**Date:** January 25, 2019  
**To:** Eric Simmons and Patrick Clancey, FEMA Region IX  
**From:** Seth Ahrens and Pani Ramalingam, STARR II  
**Subject:** Recommended Path Forward for the Carson River PMR CTP Project

This memorandum summarizes STARR II's recommended path forward for completing the Carson River PMR CTP project. The CTP is the Carson Water Subconservancy District (District). The District's contractor is HDR.

**Figure 2 – Ten levee-like structures where a Natural Valley analysis may need to be completed.**

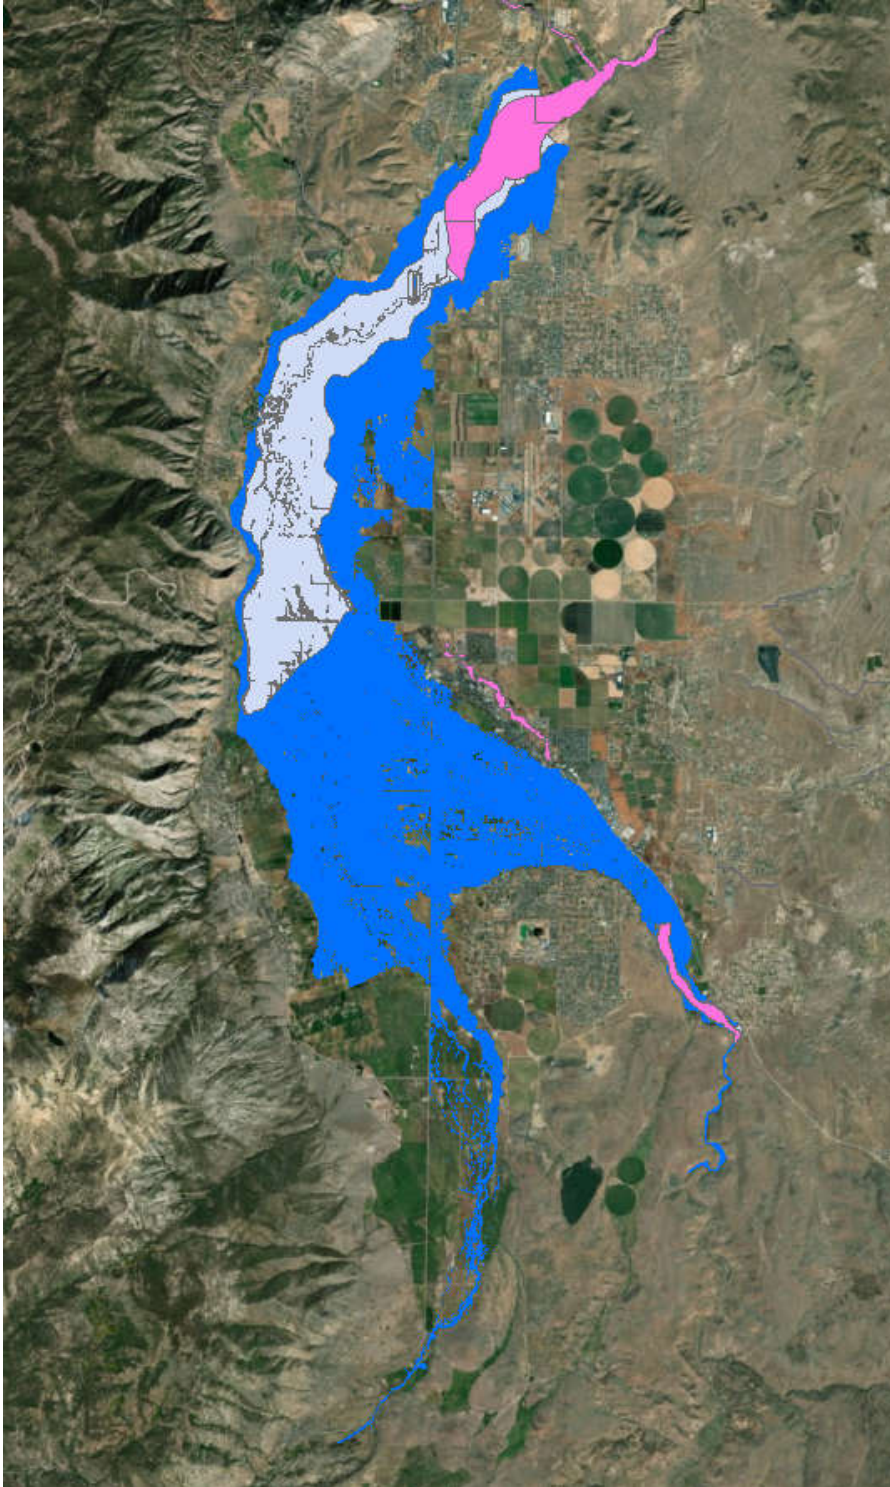
- There are 10 levees/levee-like structures in the study area for which a Natural Valley analysis should be performed. All 10 are located along the East Fork of the Carson River. Three of these structures are shown on the effective FIRM panels. The remaining seven structures were

identified from the terrain and HDR's 1% AEP event simulation. Figure 2 shows the locations of these levees/levee-like structures.

- Eight different Natural Valley simulations should be completed. The first simulation would remove structures 1, 2, and 3 on Figure 2 from the model. Each remaining simulation would remove one of structures 4 through 10 from the model.

- The 1% AEP floodplains from the 9 simulations (one baseline simulation and 8 Natural Valley simulations) can be combined to build a composite 1% AEP floodplain. This composite floodplain should be shown on the work maps.
